# Addendum to Cherwell Green Belt Study

Response to the Council's suggested Green Belt changes subsequent to the Partial Review Plan Inspector's Post-Hearings Advice Note

Client: Cherwell District Council

- 1.6 **Figure 1** below shows the proposed revised Green Belt boundaries which set out Cherwell District Council's suggested development area south-east of Kidlington, alongside those boundaries indicated in the Submission Local Plan.

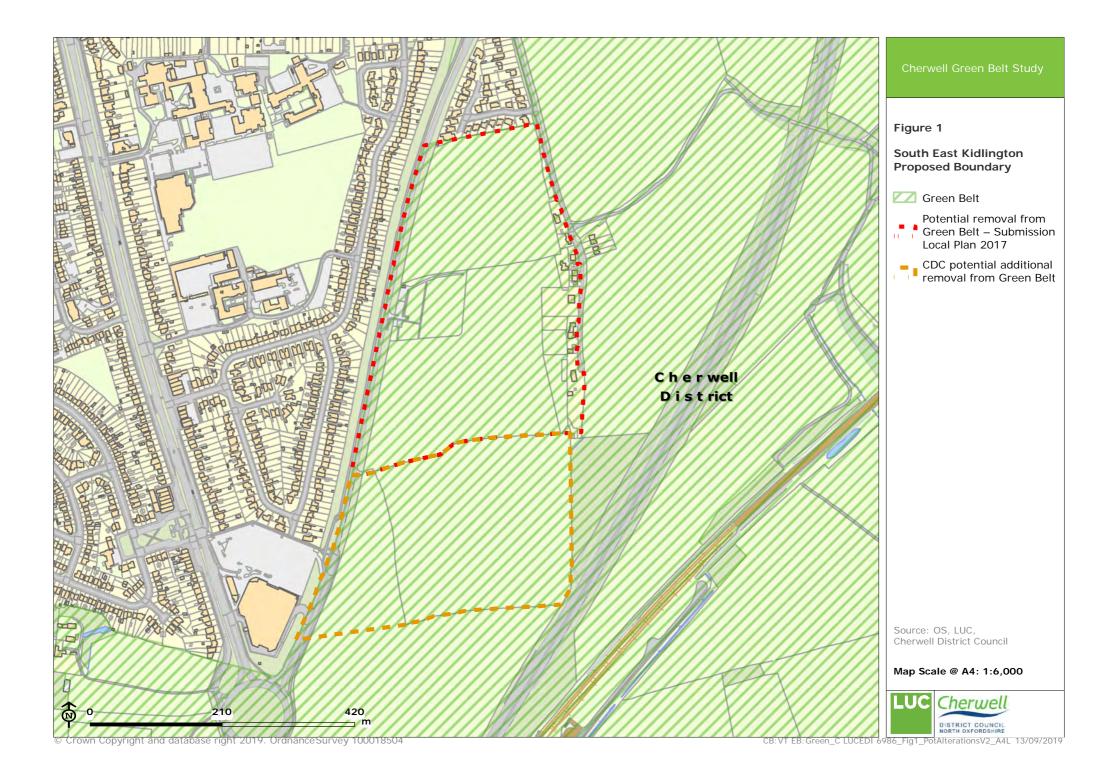
- 1.7 The revised proposals suggest release of an additional hedged field to the south of the boundary indicated in the Submission Local Plan, together with a triangle of land to the west which forms part of the large field extending south to the Kidlington Roundabout. The hedged field was identified in the Green Belt Review as part of an area (within parcel PR178) which would, if released, result in *moderate-high* harm to the Green Belt purposes, whereas release of all the land down to the roundabout was assessment as *high* harm. The key consideration in identifying this reduced level of harm was that the impact on the settlement gap between Kidlington and Oxford would be lessened i.e. by not extending the inset settlement any further south than the current edge of Kidlington. The hedgerow now proposed as the Green Belt boundary is no different in strength to the hedgerow proposed in the Submission Local Plan.

- 1.8 The triangle of land to the west was, along with the rest of the large field of which it forms part, rated at *high* harm, the boundary of the *high* harm area reflecting the presence of field boundaries. However it is recognised that if the hedged field to the east was released the triangle of land would be largely contained by inset development, and would therefore make a weaker contribution to the Green Belt purposes. The release of this area, with creation a new planted boundary, would not therefore significantly affect the remaining gap between Kidlington and Oxford.

- 1.9 Our addendum of June 2017 noted that the strength of remaining open land in PR178 as Green Belt would be reduced by release of land to the east of Bicester Road (i.e. in PR202 and PR178), with containment by inset development and major roads limiting connectivity with the wider countryside. The additional release of land would further erode the size of this contained area of open land but would not represent a step-change in Green Belt harm. As also noted in the 2017 addendum, it would be important to maximise openness and minimise urbanising elements (such as high fences), and to consider use of landscaping to assist with this. Material changes in land use such as for outdoor sport and recreation are identified in the latest version of the NPPF (at paragraph 146) as "not inappropriate in the Green Belt provided they preserve its openness and do not conflict with the purposes of including land within it".

- 1.10 Subsequent to producing our comments in relation to PR7a the Council considered an alternative boundary and produced a revised plan which shows a slightly altered course for the proposed Green Belt boundary to the west of the existing hedgerow (which would follow the alignment of a former field boundary, removed during the 20<sup>th</sup> century). The Council's plan is shown in Figure 2 below the pink shaded area represents land to be released, with the green shaded and hatched area remaining in the Green Belt. This represents some further incremental erosion of the remaining Green Belt in this area, but the additional expansion of the development area is too small to make any significant difference to the level of harm to Green Belt purposes that would result from the release shown on Figure 1.

- 1.11 **Figure 3** below shows the proposed revised Green Belt boundaries which set out Cherwell District Council's suggested development area at Stratfield Farm, alongside those boundaries indicated in the Submission Local Plan.

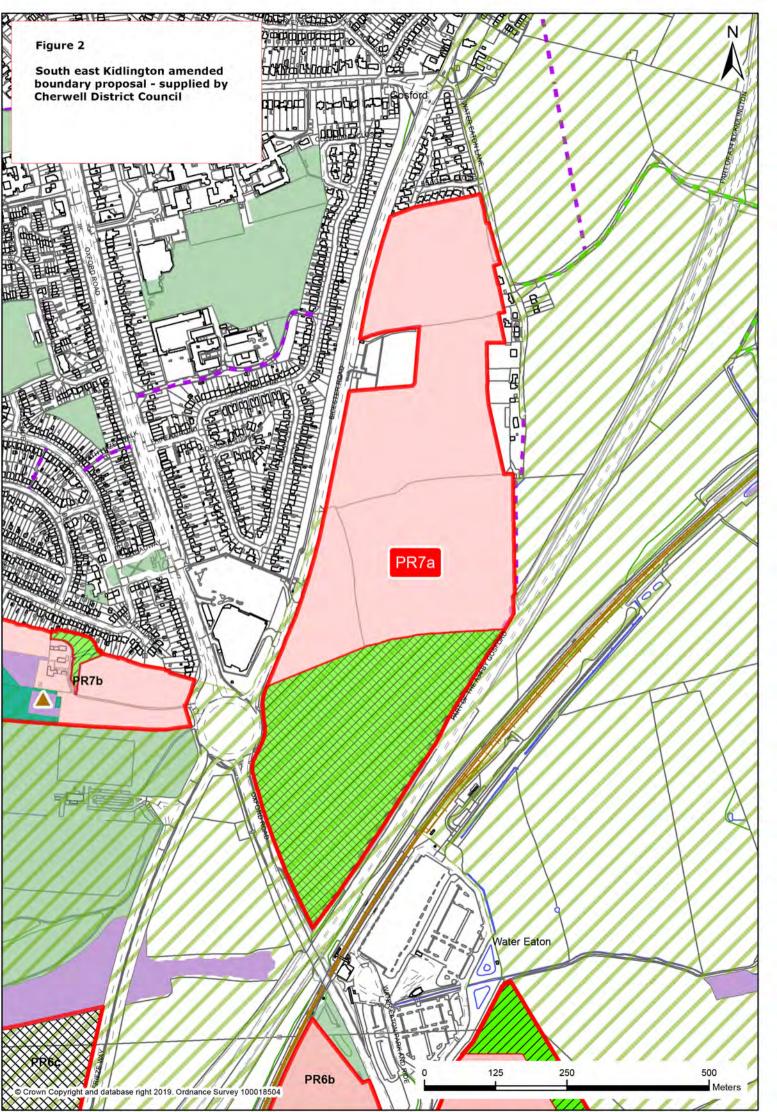
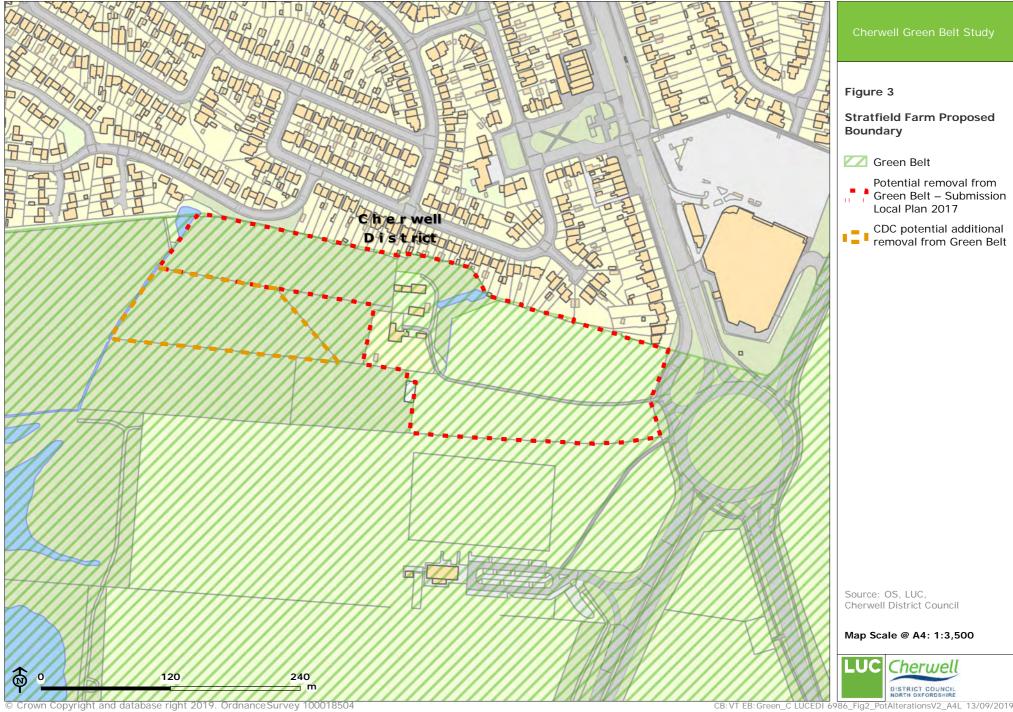
- 1.12 The additional field proposed for Green Belt release is located in the central part of parcel PR49 that was rated at *low-moderate* for harm. The field boundary hedgerow would mark a clear Green Belt edge, and although the advancement of the inset settlement edge by c.70m would not lead to a significant change in harm, either in terms of impact on the Green Belt purposes or strength of the Green Belt boundary, increased containment of the small block of trees and grassland alongside Stratfield Farm would weaken its role as a boundary feature.

- 1.13 **Figure 4** indicates a suggested minor amendment to the proposed Green Belt boundary that reduces the degree to which the block of trees and grassland would be enclosed by inset development. Increasing connectivity between this area which was identified in NERC Act S41 habitat data as a traditional orchard and possible priority grassland and adjacent remaining open land in PR49 would also be beneficial in terms of biodiversity and would provide a buffer to the woodland edge.

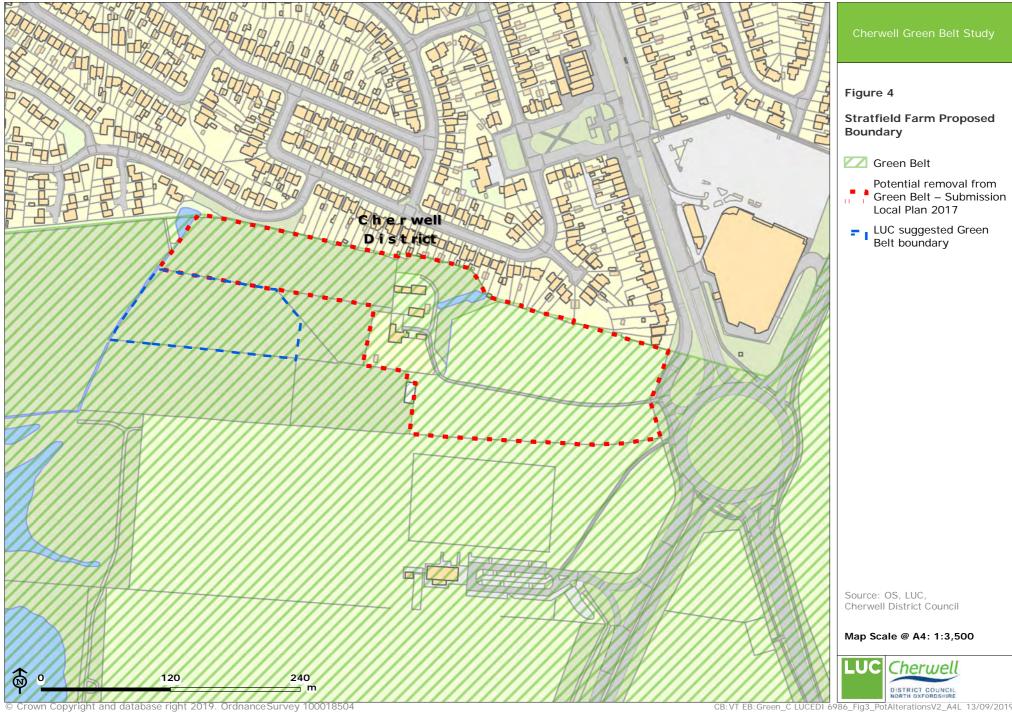
- 1.15 The Submission Local Plan's proposed western boundary for the PR9 Green Belt release followed existing field boundaries (other than a short stretch where a new school was proposed) contained between the more clearly defined area to the north and existing inset development to the south. Within PR51b, these boundaries also mark a distinction between areas closer to the inset settlement of Yarnton, rated at *moderate* and *moderate-high* harm, and land to the west which was rated at *high* harm.

- 1.16 The rising landform and absence of field boundaries in the area into which further settlement expansion is proposed are the reason for the higher harm rating, but some gradation can be identified. There is a distinction between the more gentle lower slopes on which development is proposed and the steeper hillside beyond, which is more clearly countryside separate from the inset settlement edge. The Cherwell Green Belt Study also noted that higher ground in parcel PR51b formed part of the ring of hills that constitutes a key element in Oxford's historic setting, contributing to the preservation of the City's setting and special character (the 4<sup>th</sup> Green Belt purpose), but that the lower slopes were also significant in this respect.

- 1.17 The change in slope is not dramatic, so the precise location of a new boundary would make little difference in Green Belt terms, but a new Green Belt edge approximating to the lower end of this topography (at around the 75m contour) would nonetheless define an area in which harm to the Green Belt purposes, although greater than that associated with the formerly proposed release, would be lower than the harm associated with the release of the higher slopes.

- 1.18 Ideally the new Green Belt boundary should represent a clear distinction between the inset residential area and adjacent Green Belt land. It should lie outside of residential curtilages, so that it can be managed in a way that serves this purpose. It is appropriate that the proposed parkland and woodland areas should remain as Green Belt, where they have the potential to provide improvements to environmental quality and accessibility to help offset the impact of release of land (a requirement noted at paragraph 138 of the NPPF).

- 1.19 Any smaller areas of open land that lie between the suggested parkland and new built development, and which would be likely to have a stronger physical association with the developed area than with the wider countryside, could form part of the Green Belt release, in preference to the creation of a more convoluted boundary following property curtilages. Any proposed woodland blocks should remain within the Green Belt, so that their contribution to preventing countryside encroachment has greater protection. Any land identified for potential outdoor sports should also remain in the Green Belt, but urbanising elements should be minimised, so as to preserve Green Belt openness.
